Access Audit Site Report

Inks Lake State Park

Accessibility Evaluation

Inspection Date: 08/23/2021

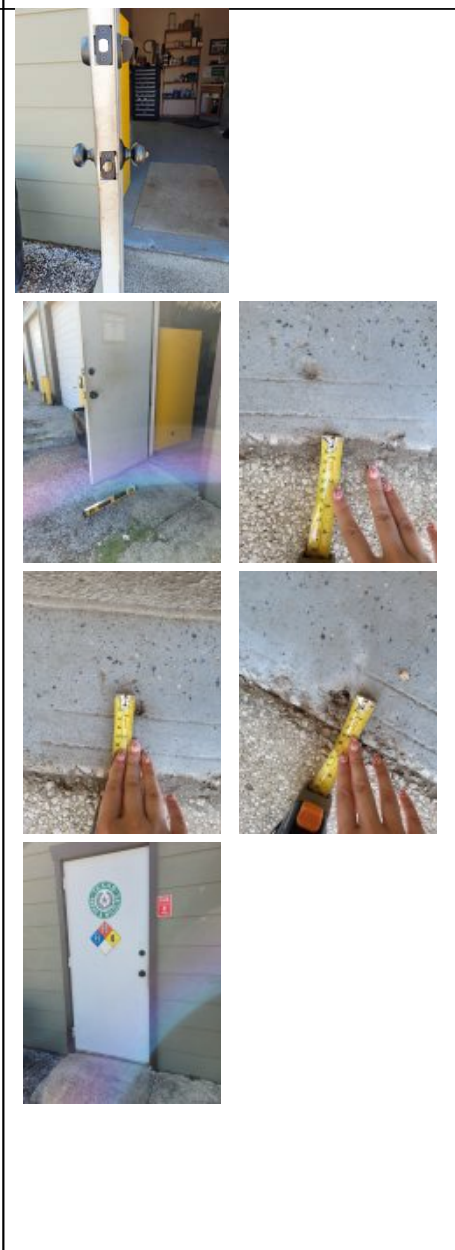
Finding Number	Area Description	Lat/Long	Finding	As Built	Recommendation	Citation	Photos	Figure
320	Employee Other: Residence	[30.7391498 , -98.3673188]	Employee residence has paved driveway with slope exceeding 2.08%. There is a change in level to enter the residence.	assistant super residence - slope on drive, step to porch	Leave as is employee residence until either renovations are made or an employee with a disability needs changes made.	Capture Section: 1		
321	Employee Other: Residence	[30.7392512 , -98.3673992]	The threshold at a doorway shall be no higher than 1/2 inch. Changes in level between 1/4 inch and 1/2 inch must be beveled at 1:2 or less. 1/4 inch is the maximum vertical rise. Hand-activated door opening hardware, handles, pulls, latches, locks, and other operating devices on accessible doors shall have a shape that is easy to grasp with one hand and does not require tight grasping, tight pinching or twisting of the wrist to operate. Hardware shall be 34 inches minimum and 48 inches maximum above the finish floor or ground. There is no route connecting the driveway to the entry of the employee residence.	garage door at residence - knob hardware, 2" step up. no AR	Leave as is employee residence until either renovations are made or an employee with a disability needs changes made.	2010 ADAS Section: 404.2.3, 404.2.7, 404.2.4, 404.2.11, 404.2.11 Exception

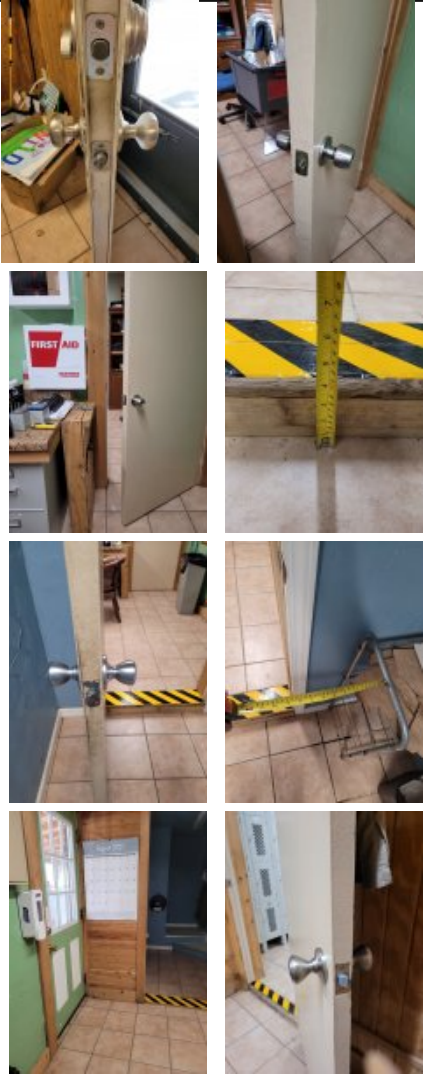
Finding Number	Area Description	Lat/Long	Finding	As Built	Recommendation	Citation	Photos	Figure
329	Employee Other: Maintenance	[30.73737, -98.36903]	Openings in floor or ground surfaces shall not allow passage of a sphere more than 1/2 inch (13 mm) diameter except as allowed in 407.4.3, 409.4.3, 410.4, 810.5.3 and 810.10. Elongated openings shall be placed so that the long dimension is perpendicular to the dominant direction of travel.	2" gap	Fill and maintain gaps to max .5"	2015 ABAAS Section: 302.3 2012 TAS Section: 302.3 2010 ADAS Section: 302.3		
330	Employee Other: Maintenance	[30.73737, -98.36903]	The top of the work surface is not within a compliant height range. The tops of tables and counters shall be 28 inches to 34 inches from the floor or ground.	2 tables, none accessible	Provide tables and work surfaces at 28" to 34" aff with required knee and toe clearances	2015 ABAAS Section: 902.3 2012 TAS Section: 902.3 2010 ADAS Section: 902.3

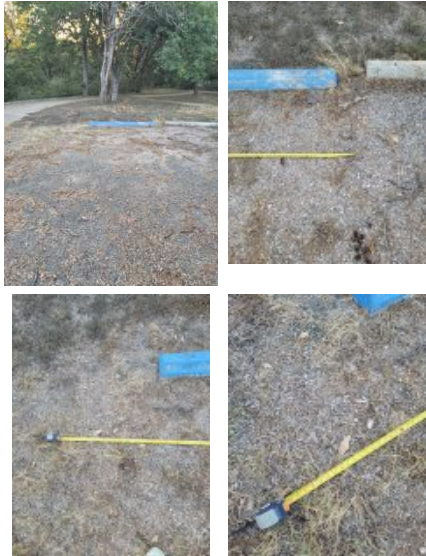
352	Campsites: Campsites	[30.7410194, -98.364172 5]	An accessible access route is not provided between elements, spaces and the facilities provided within the accessible camping unit. At least one outdoor recreation access route shall connect accessible elements, spaces and facilities provided within camping units with mobility features.	site 58 - no route to table area	Create AR with crushed and compacted stone or similar outdoor material to camp sites and one of each type of amenity.	2015 ABAAS Section: F244.5.1
